EIA REPORT

Copies of Correspondence from
I&APs during Scoping and
EIA Phases

Scoping and Environmental Impact Assessment for the Proposed Development of a 75 MW Solar Photovoltaic Facility (KENHARDT PV 3) on the remaining extent of Onder Rugzeer Farm 168, north-east of Kenhardt, Northern Cape Province

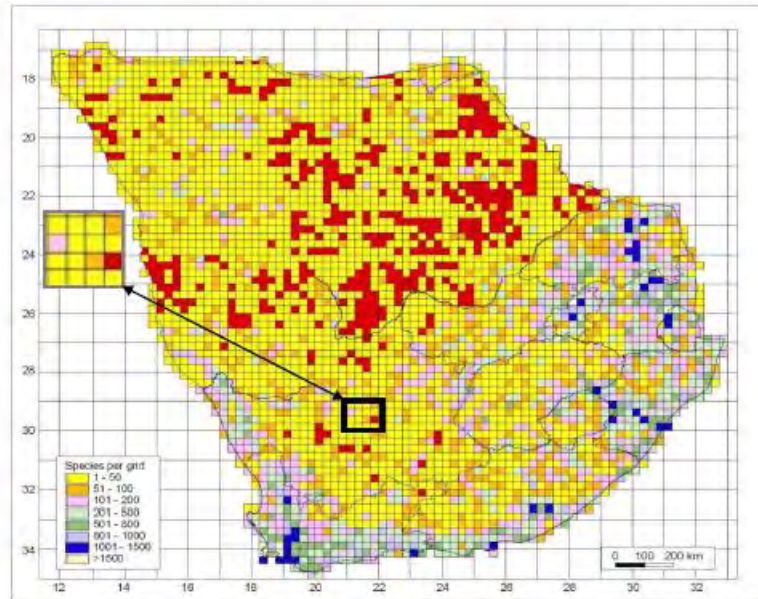
1. It should be noted that the areas where the proposed developments are to be constructed have been historically poorly surveyed, hence extrapolations from desktop studies for specialist's studies will give an incomplete representation of the biodiversity within the area (refer to Figure 2).

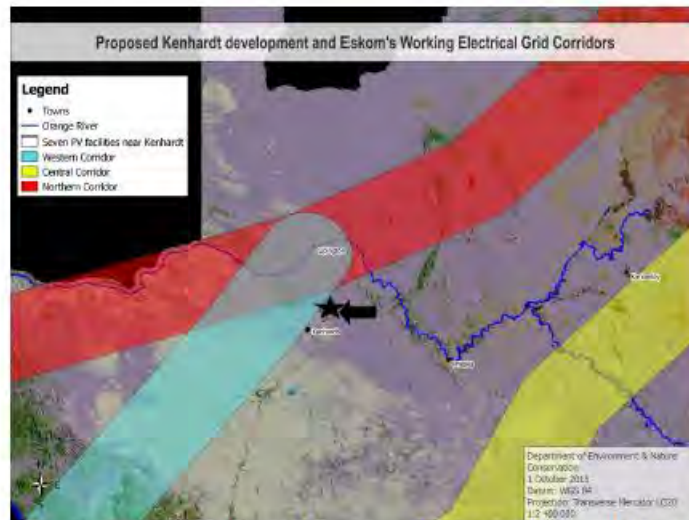
3. The proposed development do not form part of the Strategic Environmental Assessment (SEA) for Eskom's electricity grid upgrades and roll-outs as it falls outside one of the corridors identified by Eskom (i.e. the Western Corridor; one of the five identified corridors; refer to Figure 3). Comprehensive field surveys (within appropriate seasons) should thus be done for this specific area; it didn't form part of Eskom's assessment and the former project's surveys can thus not be used as baseline studies.

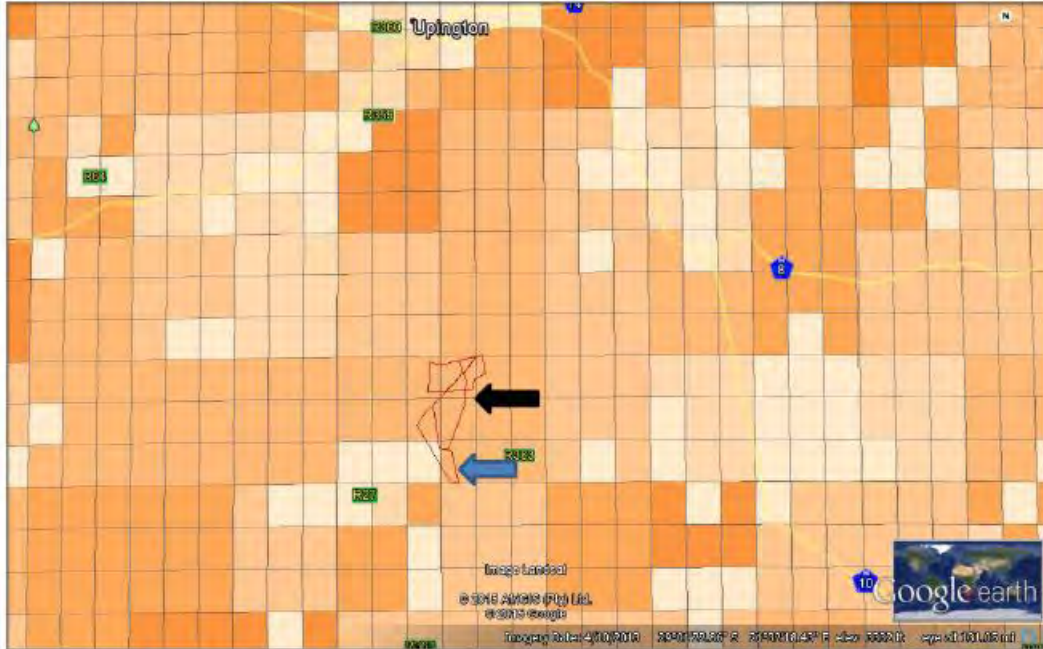
4. The proposed area does not fall within or close to an Important Bird Area (IBA), yet it does resort within a region of grids classified as being sensitive to Wind Farm facilities (refer to Figure 4). The darker the pendent the more sensitive the specific area is to Wind Farm facilities. Closer scrutiny regarding bird studies is thus a prerequisite due to possible impacts of birds on grid infrastructure as by implication local or regional migratory species that move around in response to surface water availability may be at risk from infrastructure collisions. It is also critical to point out that bird data for this area is based on the South African Bird Atlas Project 1 (SABAP1); data published in 1997 and recorded at a much broader scale than the SABAP2 data survey. Evidently, one can conclude that data for this area is outdated. This is specifically highlighted as a point of concern as each of the three PV projects will be separately linked to the Eskom grid through its own set of powerlines.

Figure 5. Several landscape scale connections through drainage lines are evident within the area in question. The two proposed facilities i.e. the Three Solar PV (blue arrow) and Seven Solar PV (black arrow) are to be located in close proximity of drainage lines and wetlands.

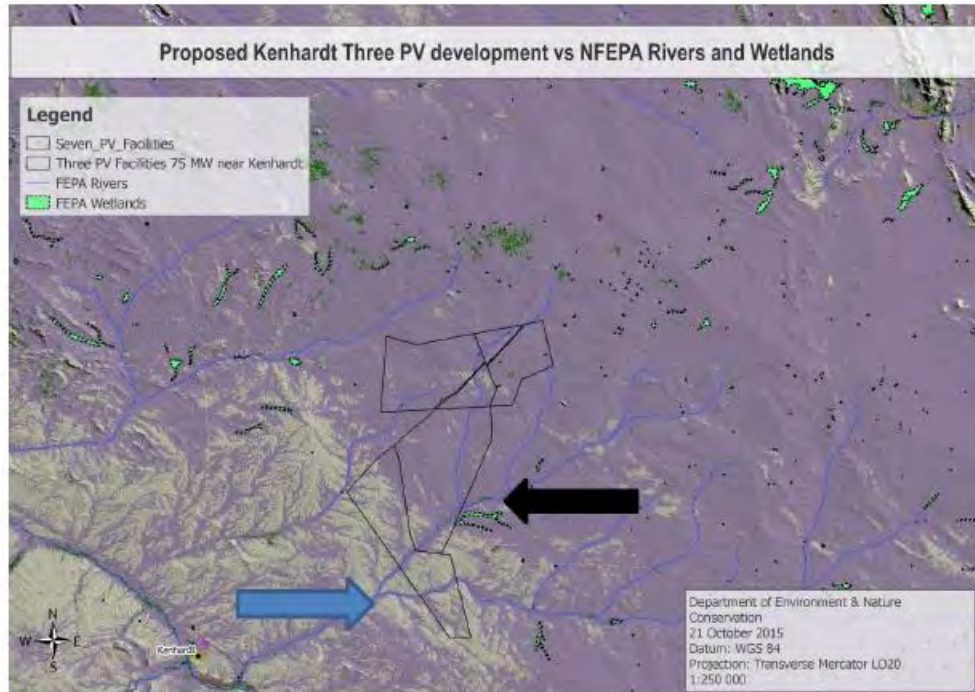
vegetation types is poorly conserved in formal protected areas and extensive areas have been historically overgrazed. As a result, large areas are currently degraded and drainage lines have been modified as a result of anthropogenic impacts. As a result of the extent of the area, impact would most likely be on landscape connectivity as the site is in close proximity of drainage lines and wetlands (refer to Figure 5).

- 6.2 Above-mentioned areas should be noted as sensitive areas during the EIA phase.
7. The disturbance of soil and indigenous vegetation can initiate the prolific growth of invasive alien plants (IAPs). The latter should be avoided by all means as it has detrimental impacts on indigenous faunal and floral species, as well as underground water resources. A proper IAP management plan must thus be factored into the EIA phase (as part of the EMP). Please consult the National Environment Management: Biodiversity Act's (Act No. 10 of 2004) Regulations on Alien and Invasive Species as promulgated on 1 August 2014.
